UNITED STATES PATENT AND TRADEMARK OFFICE

APPLICATION NO.	FILING DATE	FIRST NAMED INVENTOR	ATTORNEY DOCKET NO.	CONFIRMATION NO.
10/664,695	09/22/2003	Ramani Mani	125643-1	5199
6147 7590 06/07/2007 GENERAL ELECTRIC COMPANY GLOBAL RESEARCH PATENT DOCKET RM. BLDG. K1-4A59 NISKAYUNA, NY 12309			EXAMINER RODRIGUEZ, WILLIAM H	
			ART UNIT 3746	PAPER NUMBER
			MAIL DATE 06/07/2007	DELIVERY MODE PAPER

Office Action Summary

DETAILED ACTION

US 3,572,960 particularly figure 1

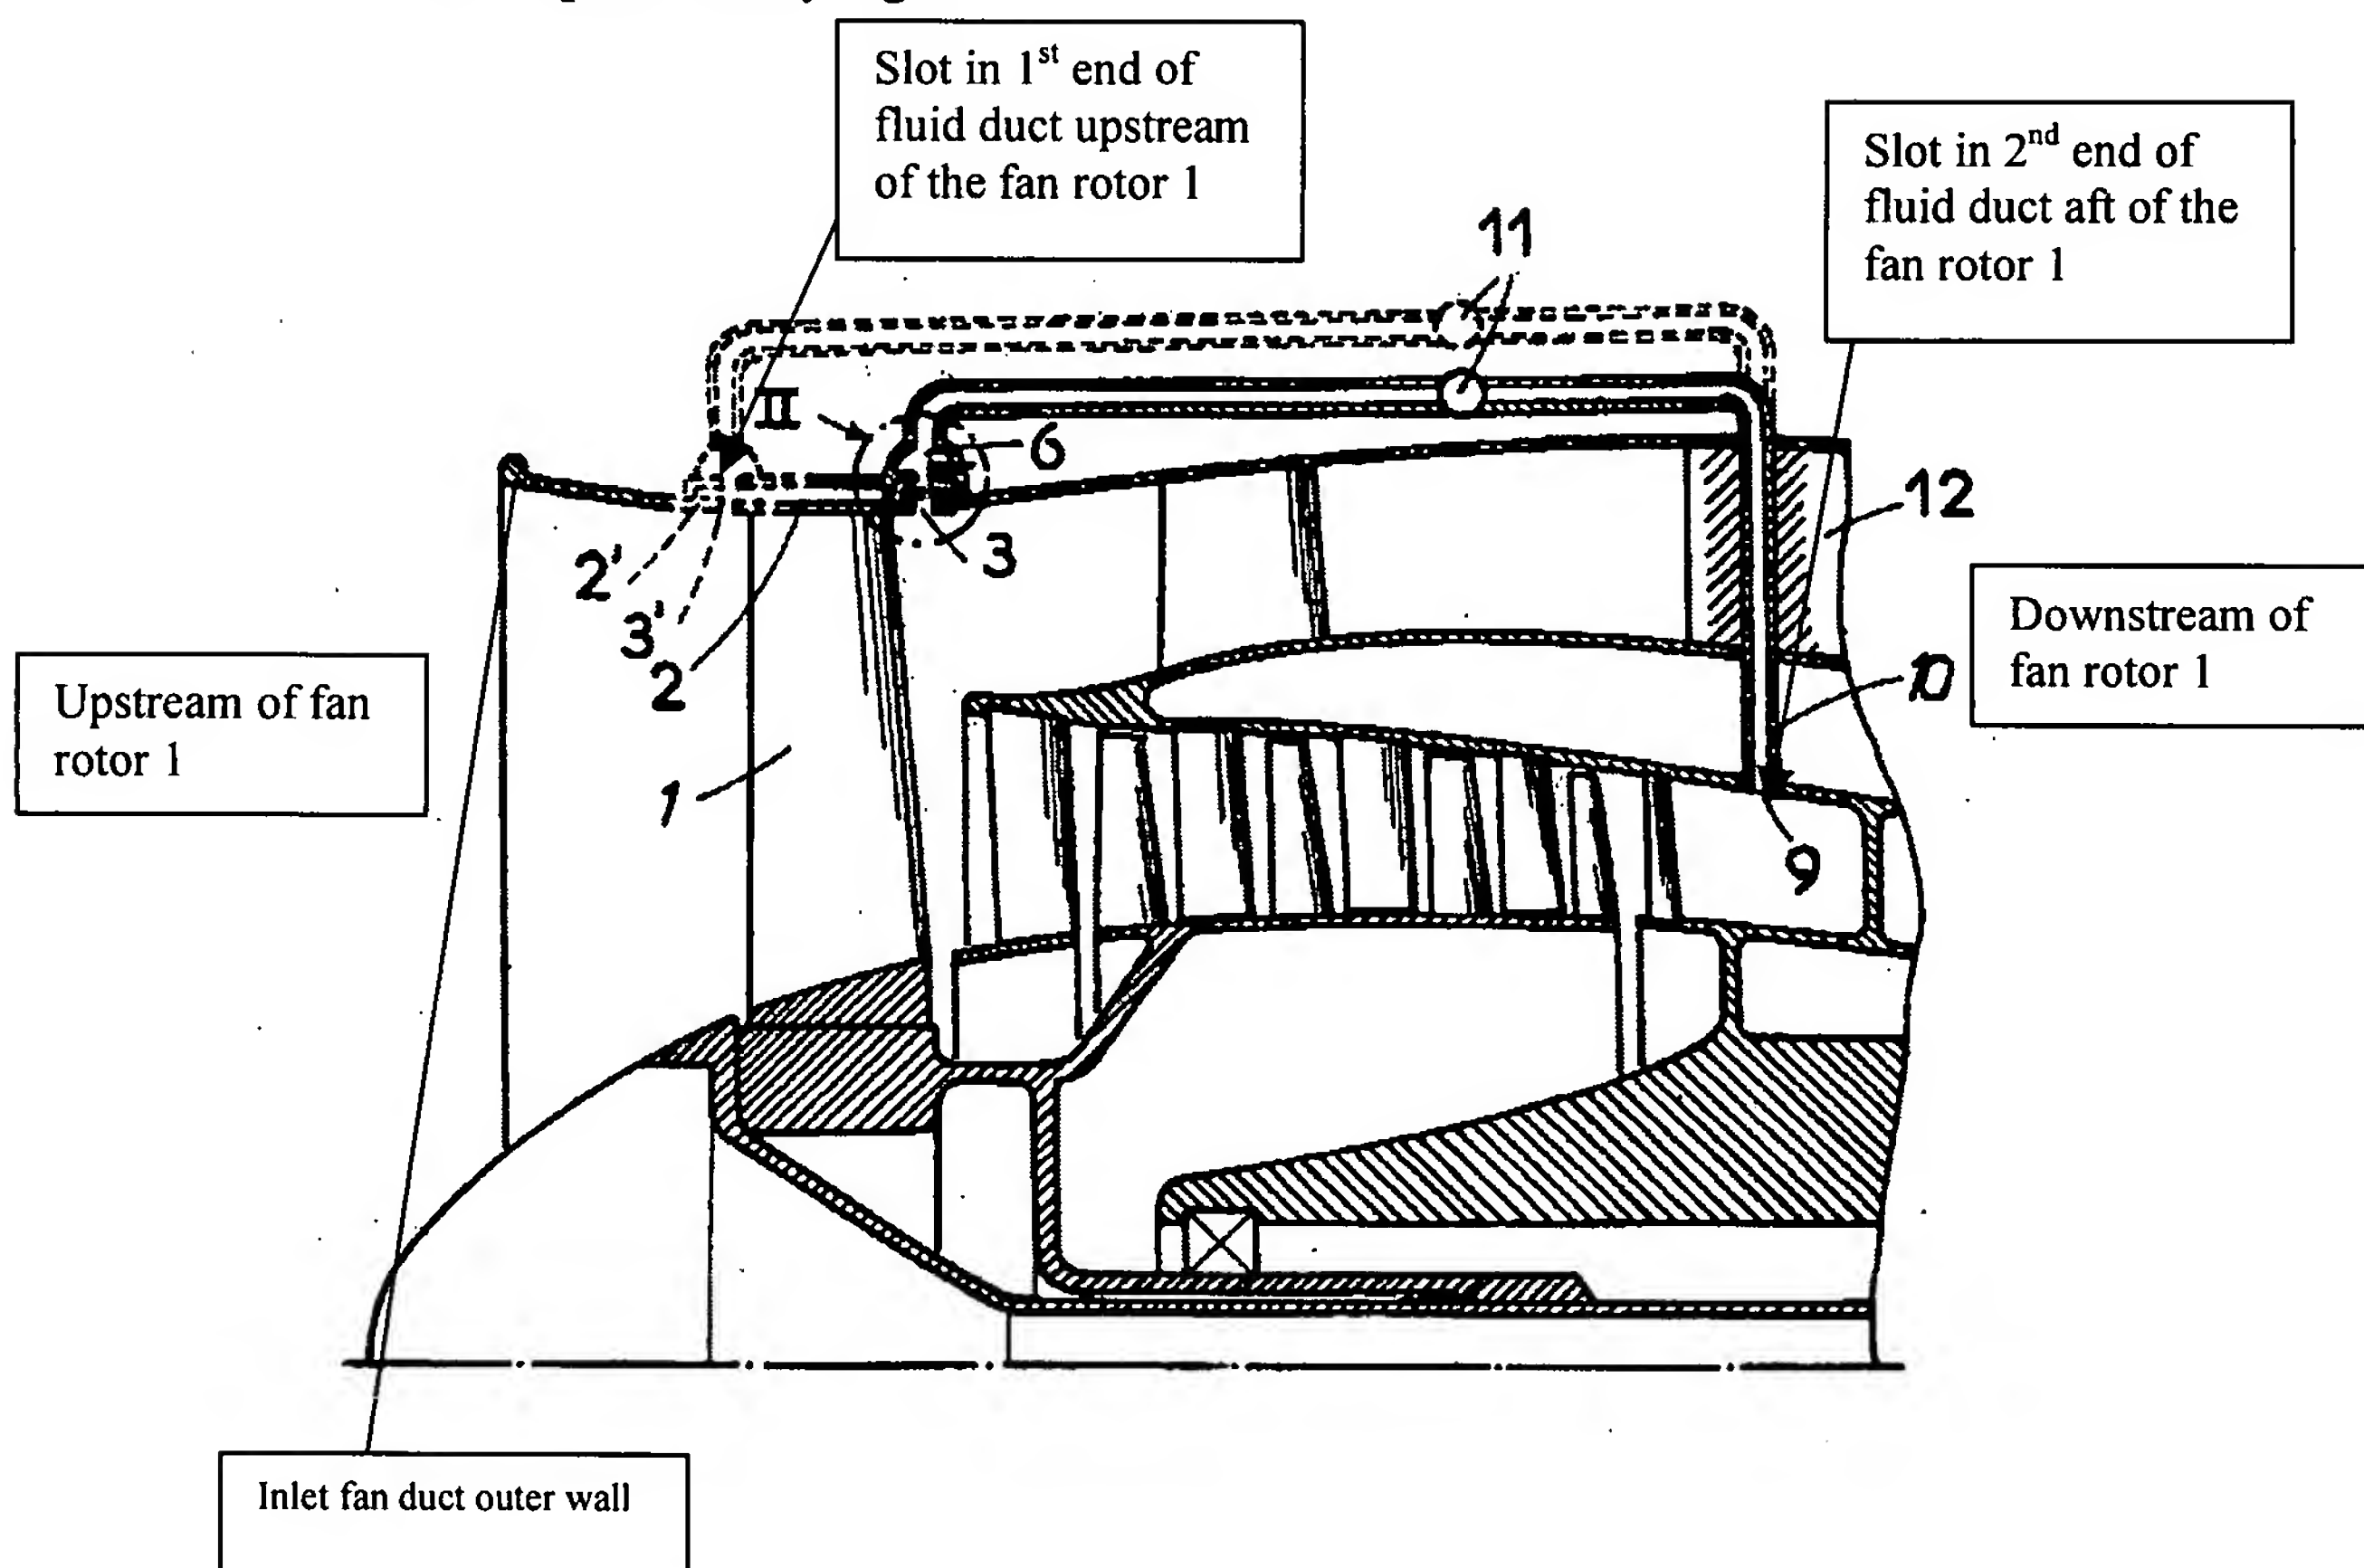
7. The prior art made of record and not relied upon is considered pertinent to applicant's disclosure.
